SERVICE BULLETIN

SERVICE BULLETIN		No.: MSB-99E55-503		
		Date: 1999-12-15	<Model> (EC,EXP) L200 (K00)	<M/Y> 97-10
Subject: OMISSION OF DISASSEMBLY / REASSEMBLY OF A/C COMPRESSOR ASSEMBLY				
Group: HEATER, A/C & VENTILATION		Draft No.: 99SY060115		
CORRECTION	INTERNATIONAL CAR ADMINISTRATION OFFICE	T.NITTA - PROJECT LEADER AFTER SALES SERVICE & CS PROMOTION		
1. Description: Omission has been rectified of a description of the disassembly / reassembly of the A/C compressor assembly under Compressor and Tension Pulley.				
2. Applicable Manuals:				
Manual		Pub. No.	Language	Page(s)
'97 L200 Workshop Manual Chassis		PWTE96E1	(English)	55-5, 32
		PWTS96E1	(Spanish)	
		PWTF96E1	(French)	
		PWTG96E1	(German)	
3. Details: '97 L200 Workshop Manual Chassis, page 2,3,4,5

Magnetic clutch disassembly steps

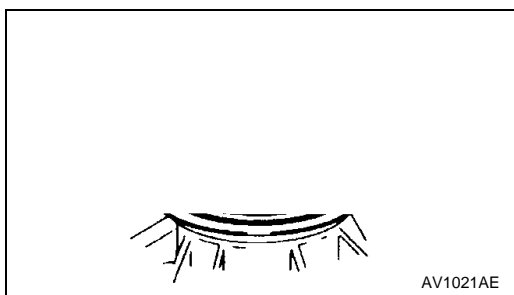
- Air gap adjustment
- 1. Armature plate
- 2. Shims

- 3. Snap ring
- 4. Rotor
- 5. Snap ring
- 6. Clutch coil

◀ A ▶ ARMATURE PLATE REMOVAL

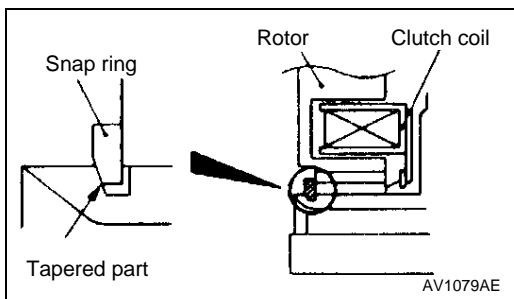
▶ A ▶ SNAP RING INSTALLATION

Install the snap ring so that the tapered surface is at the outer side.

<Added>

►B◄ AIR GAP ADJUSTMENT

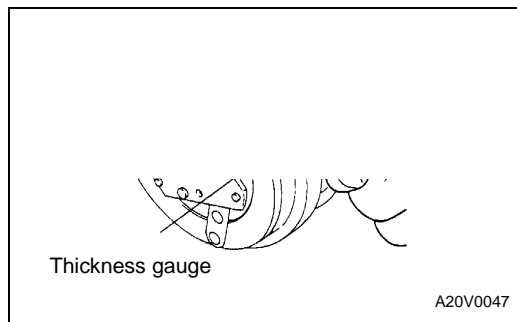
Check whether or not the air gap of the clutch is within the standard value.

Standard value: 0.3 – 0.6 mm

If there is a deviation of the air gap from the standard value, make the necessary adjustment by adjusting the number of shims.

<Added>
